GEOTECHNICAL REVIEW

Project Name: 18 Midford Lane, Limpley Stoke, Bath

Reference: ML-BWB-ZZ-XX-TDN-GE-4001-S1-P01.1

Figure 2-5: Inferred top of intact limestone, GeMech pile installation records.

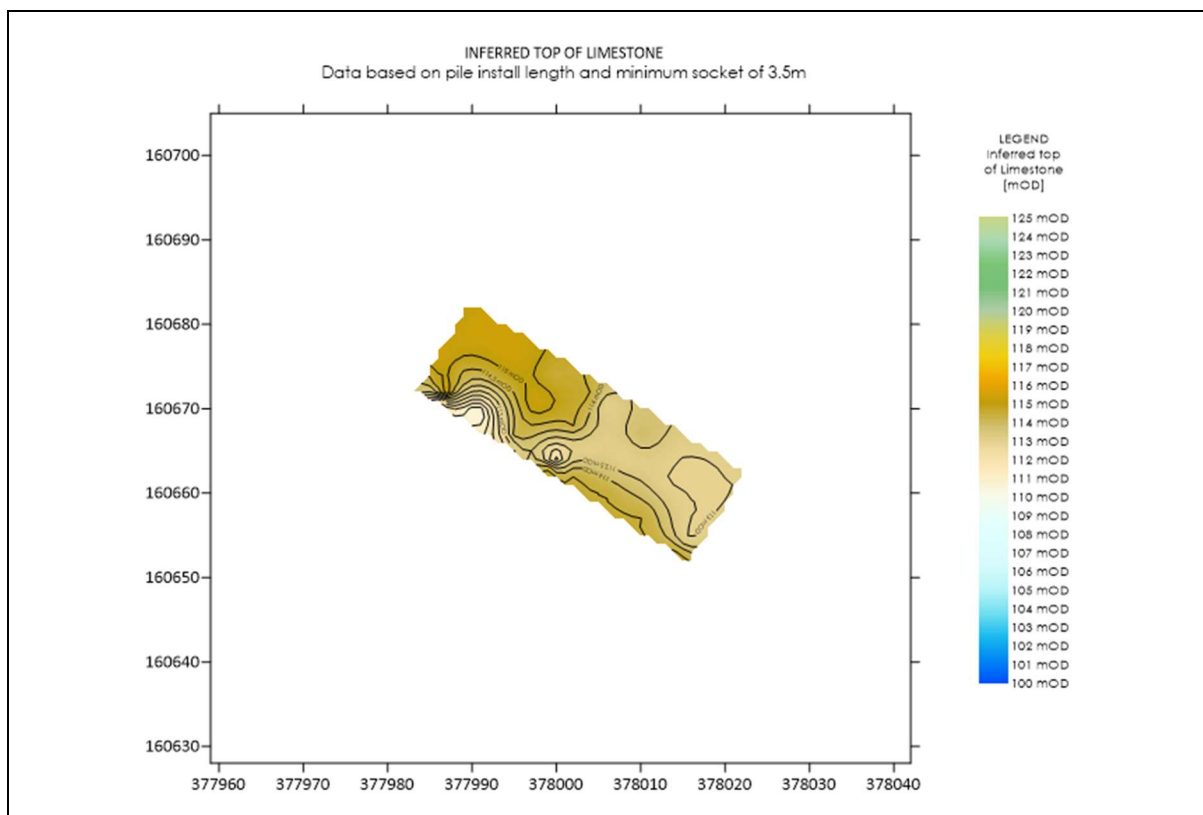
Based on the records of the pile installation by GeMech, a surface was also produced based on the inferred top of the instance limestone. As the data was limited to where piles had been installed, the extent of this surface was limited to the building outline.

Figure 2-6: Typical cross-section through Ground Model

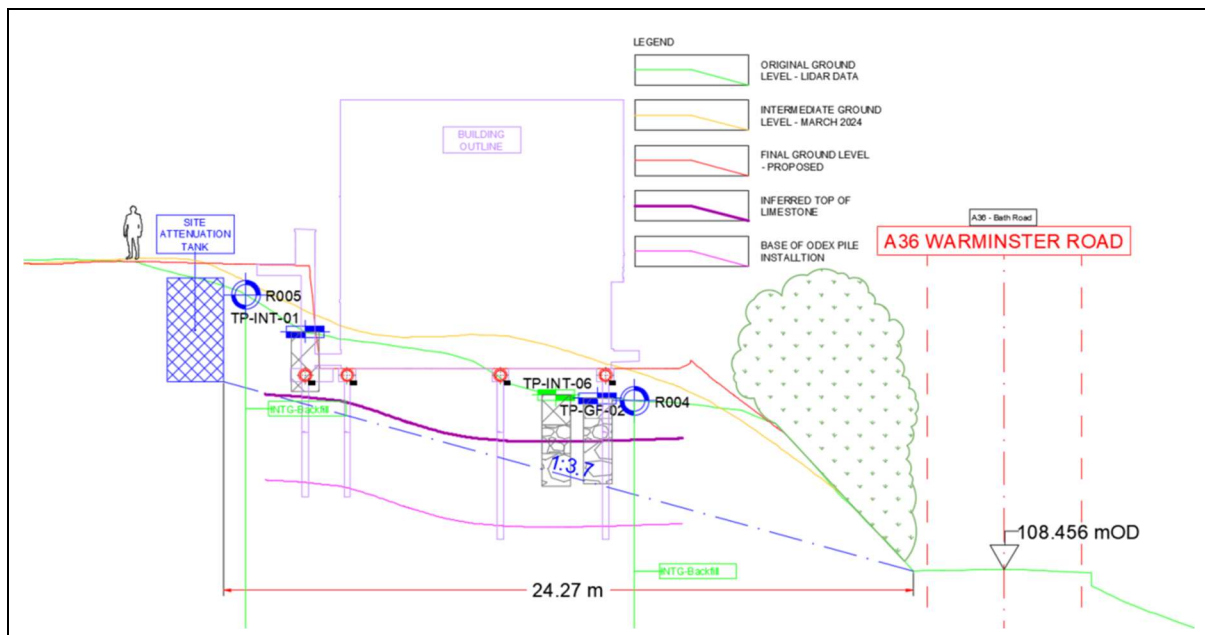
Figure 2-6 presents a typical cross-section through the ground model. The section contains a lot of information, from a range of sources, as summarised below:

- This is presented as a solid dark red line, and is set 3m above the base of the installed piles
 - A second line is presented as the modelled base of the piles, noting the pile locations as shown are the closest to the section line.

- Attenuation tank.
 - This is presented as a hatched blue block and is located to the left (West) of the new buildings.
 - A blue hatched line from the base of the attenuation tank, to the edge of the site/A 36 Warminster road is presented, along with the corresponding slope.

Plate 3.1: Typical pillar & stall mine workings, Coombe Down mine. Publicly available image.

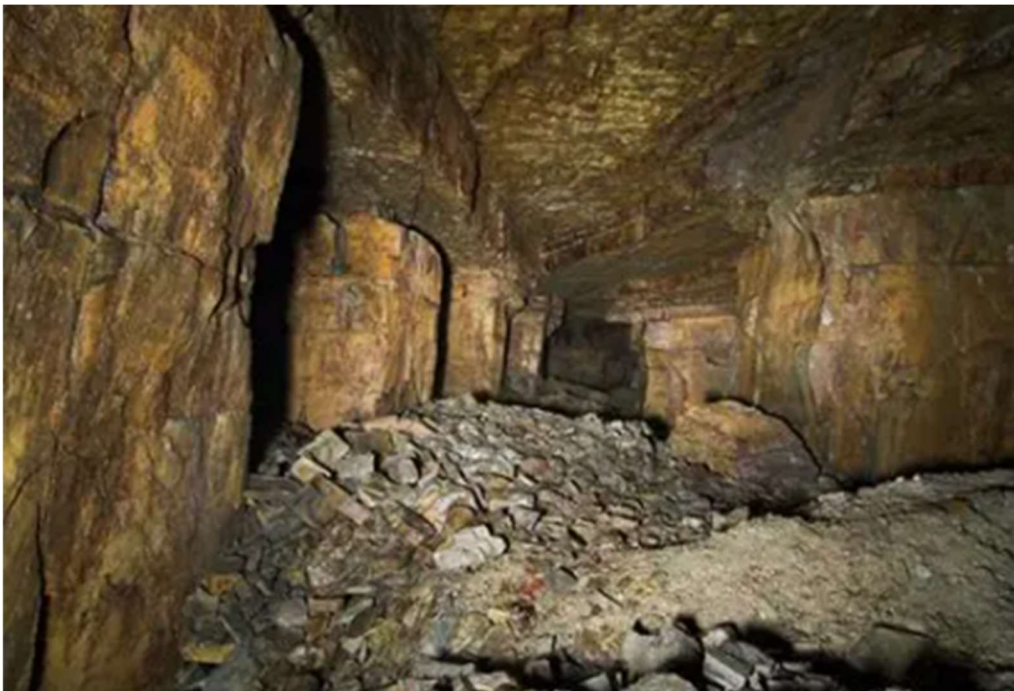
Consideration has been given to the process of pillar and stall workings including the competency of the overlying stone that would permit a stable roof to be formed between columns, to allow the workers to excavate the limestone. An example of the inside of pillar and stall workings, from the nearby Coombe Down mine, is presented as Plate 3.1.

Whilst Plate 3.1 clearly shows part of the roof, over time, has spalled and fallen to the ground, it is clear that the roof itself must have a sufficient level of competency so as to be able to span between pillars. From comparison between the exposed face of the limestone presented in Section 2, and in particular Plate 2.1 and 2.3m the highly weathered limestone is not considered to have been able to span between columns.
